June 9, 2015 Medway Planning and Economic Development Board 155 Village Street Medway, MA 02053

Village Estates Definitive Subdivision Plan – Request for Plan Endorsement and Review Construction Services Estimate from Tetra Tech:

Village Estates Plan/COA Review

PLAN & PROFILE SHEET 4 OF 8

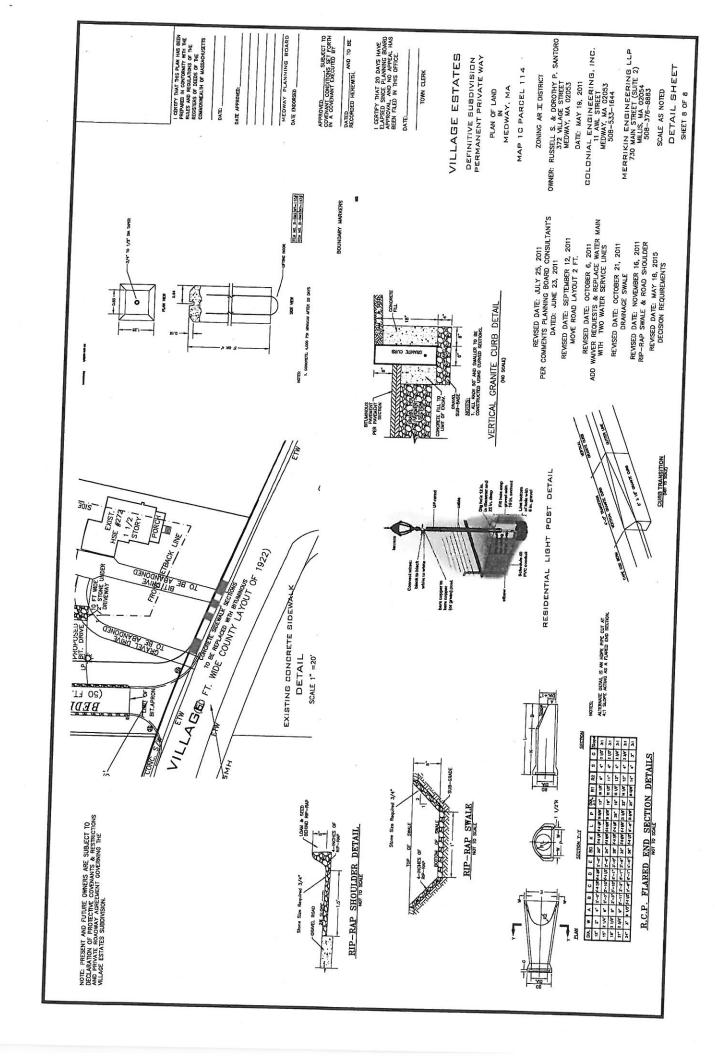
- 1. The profile of the roadway on Sheet 4 shows a proposed 8" DICL water main which a waiver was requested and approved by the board to waive that requirement. However, the plan view shows the water installation correctly as approved with two 1 ½" services being tapped off of the Main in Village Street. (Section 7.6.2b)
- 2. The applicant has not provided the note that "present and future owners are subject to a *Declaration of Protective Covenants & Restrictions and Private Roadway Agreement Governing the Village Estates Subdivision.*" (Condition 6)
- 3. The applicant has not provided the location/specification for the proposed post lights to be located at each house. (Condition 6)
- 4. Reference to the Subdivision Covenant has not been provided on the cover sheet of the plan set. (Condition 19)

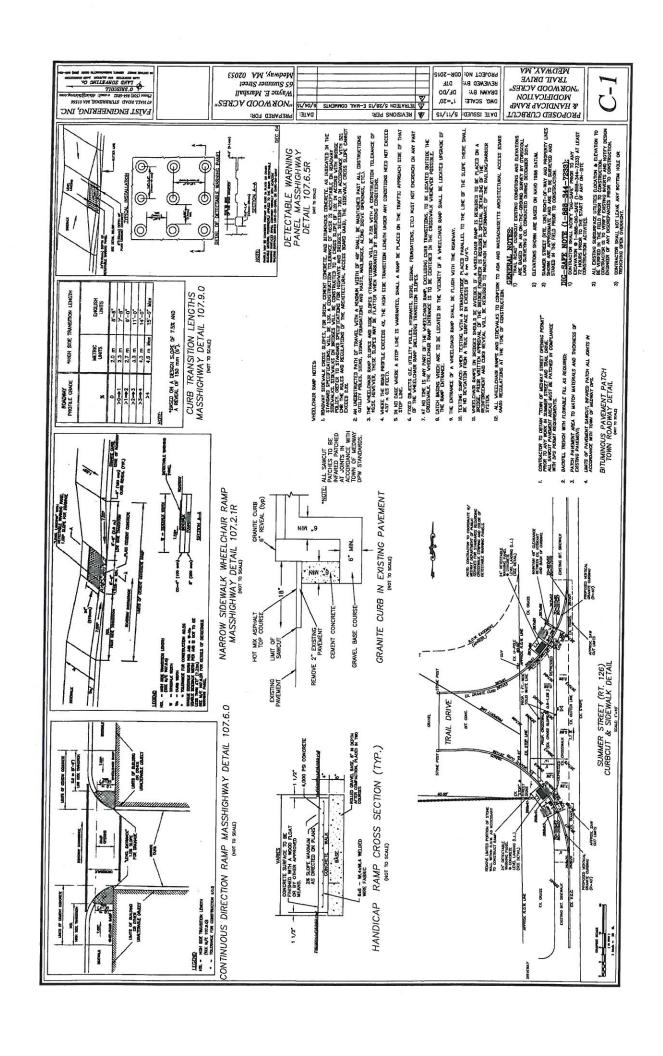
3. The applicant may want to add a note stating to coordinate with Medway DPS for standards regarding crosswalk and striping color of the detectable warning panels.

A note is now shown on the plan and we will also forward a copy of the plan to Medway DPS.
